<b>265 The Ridgeway</b>	<b>P/1492/20</b>
-------------------------	------------------

# LONDON BOROUGH OF HARROW

## PLANNING COMMITTEE

**APPLICATION NUMBER:** P/4192/20  
**VALIDATE DATE:** 13/05/2020  
**LOCATION:** 265 THE RIDGEWAY, HARROW, LONDON  
**WARD:** WEST HARROW  
**POSTCODE:** HA2 7DA  
**APPLICANT:** C/O AGENT  
**AGENT:** DANIEL WATNEY  
**CASE OFFICER:** SELINA HOTWANI  
**EXPIRY DATE:** 20/05/2021

**Image 1: Townscape view location**

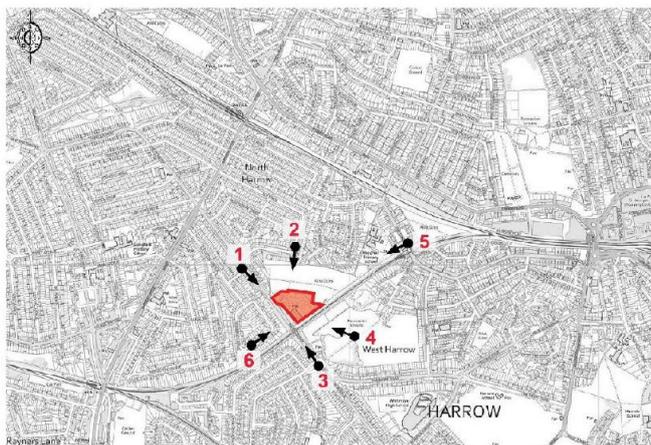
Visual Impact Assessment The report shows seven viewpoints and the proposed development would be visible to greater or lesser extents from all of the views. View 4 West Harrow Recreation Ground, from the central east west path through the park. This view illustrates clearly the change of view in the park, with the proposed new development being highly visible and the visual impact the proposed flats would have on the park. To the west side of the park when standing in the nature area ((south west corner) and the tennis courts the scale and mass of the proposed development would dominate the view to the west. The proposed development would also have a high visual impact on the allotments to the north, changing the outlook, from semi –rural to urban built form, with unattractive views of the proposed flats and housing, which would dominate the space. In close proximity, the new development would be highly visible, changing the appearance of the site from semi rural to urban, which would be out of character with the surrounding more sub – urban and semi-rural area.

Block G - Proposed Floor Plans

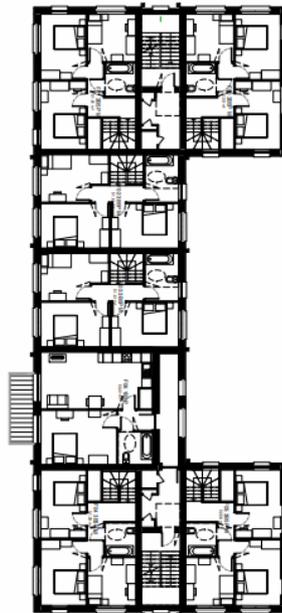
The plans submitted for Block G are very concerning, the overall layout and design will not achieve a Secured By Design accreditation, this block requires a redesign, addressing the internal void areas, which could be exploited by criminals to commit crime and ASB. Full advice can be given to the architects, free of charge by myself or any other Metropolitan police design out crime officer.
